**ADDENDUM  
NO. 1**

**June 5, 2024**

**Connersville High School & Frazee Elem. Renovations  
1100 Spartan Drive – High School  
600 West Third Street – Frazee Elem.  
Connersville, IN 47331**

**Addendum One (AD.01)** to the drawings and specifications prepared by Gibraltar Design for **Frazee Elementary School and Connersville High School Natatorium Renovations** for Fayette County School Corporation, Connersville, Indiana.

**EL101F**

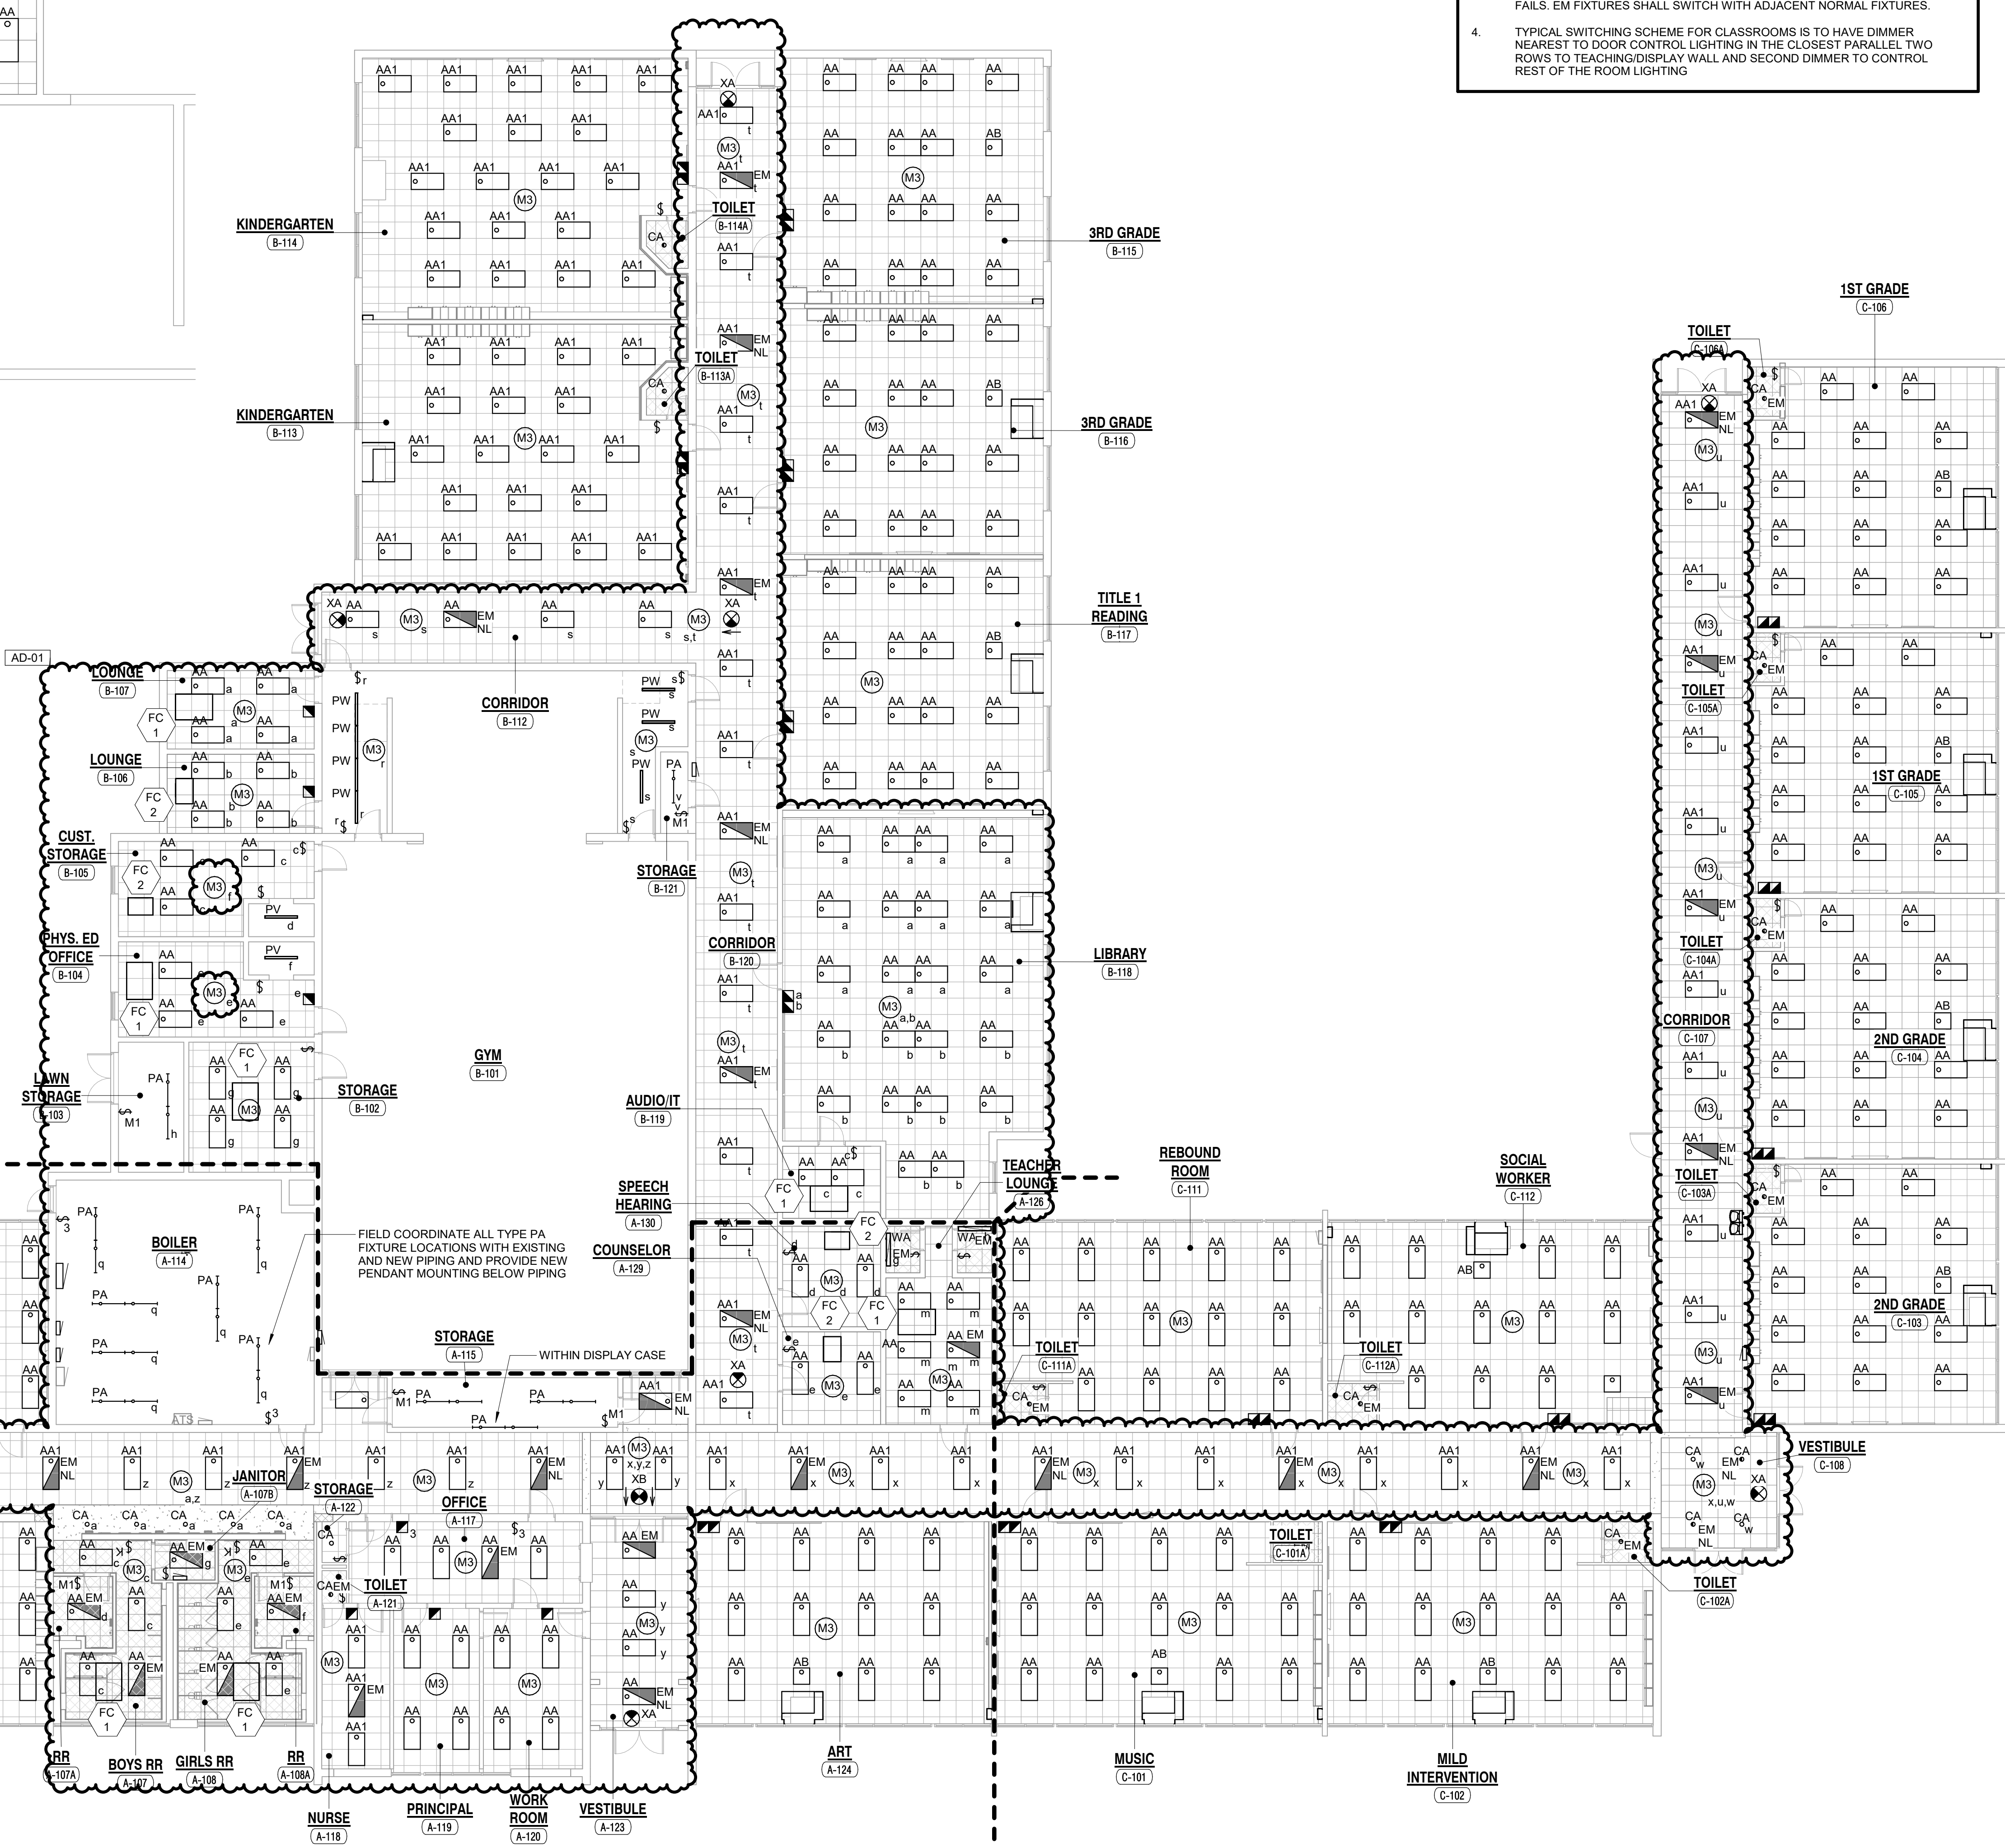
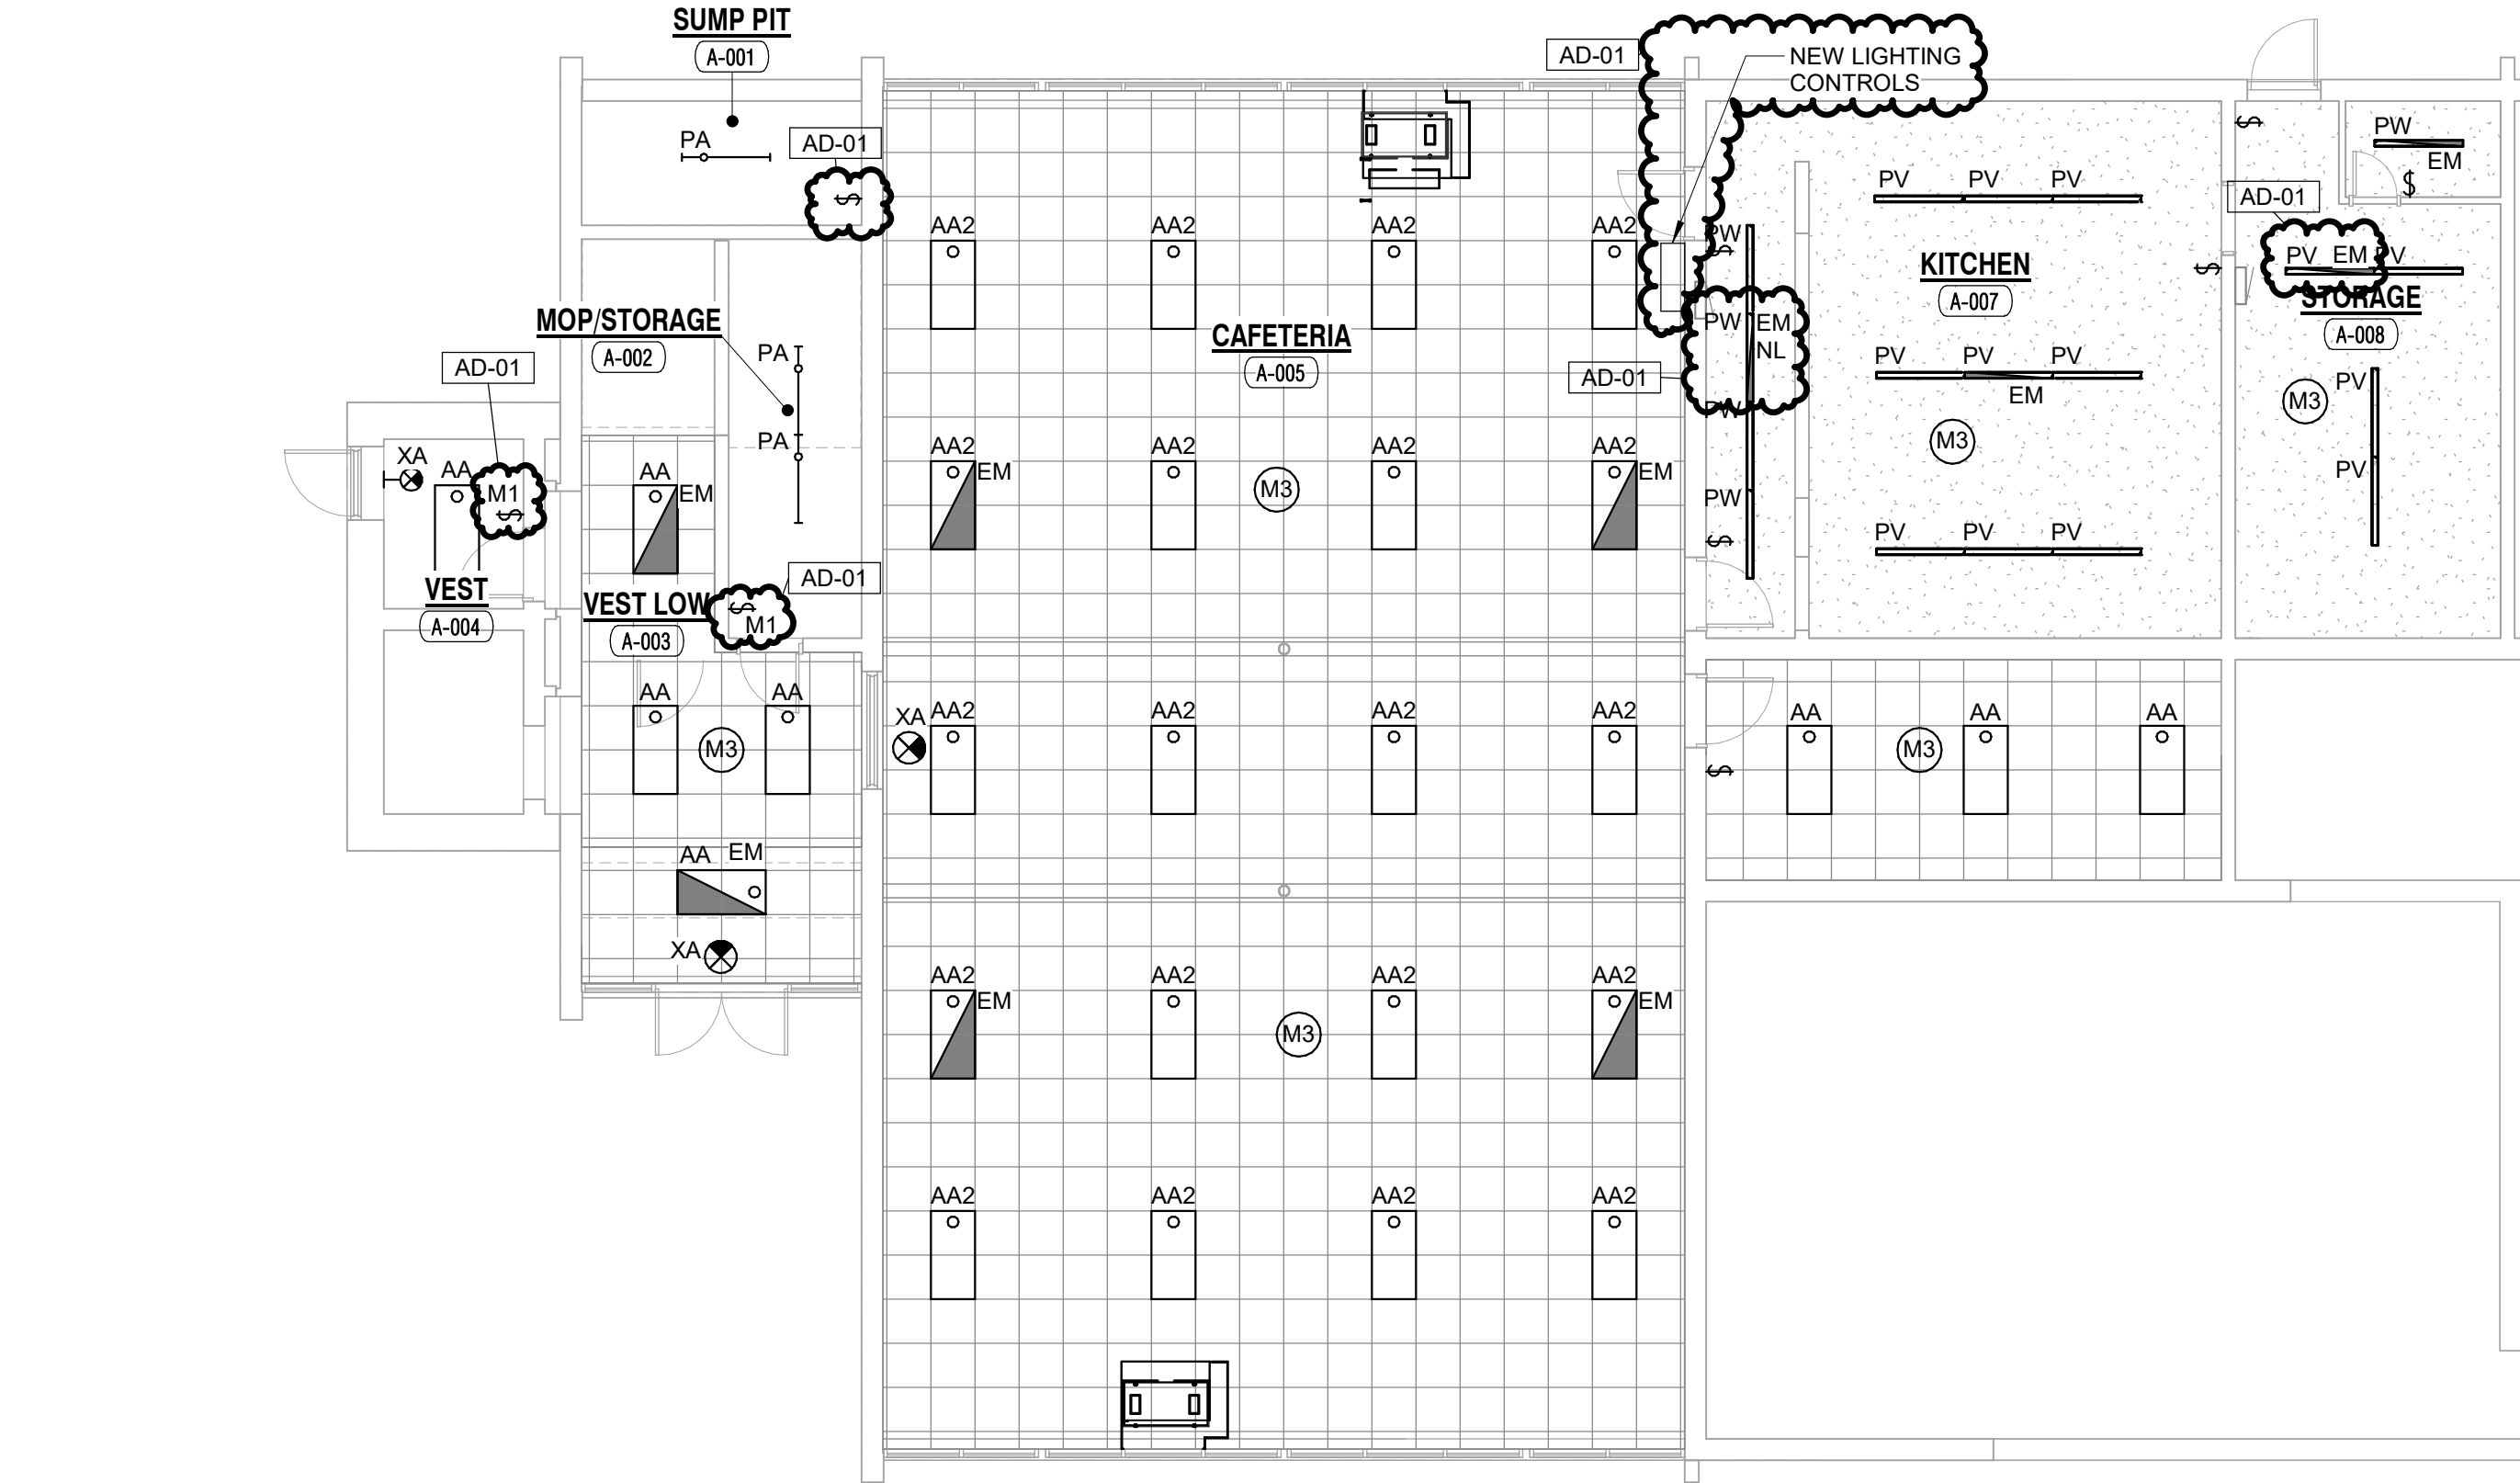
**8. Sheet EL101F**

- A. Refer to revised full size drawing included in this addendum, for the following revisions:
1. New lighting controls in Lighting Lower Level Plan – Unit A.
  2. New lighting controls in Electrical Lighting Overall Plan.
  3. Add typical classroom zoning note in 4<sup>th</sup> Grade A-111.
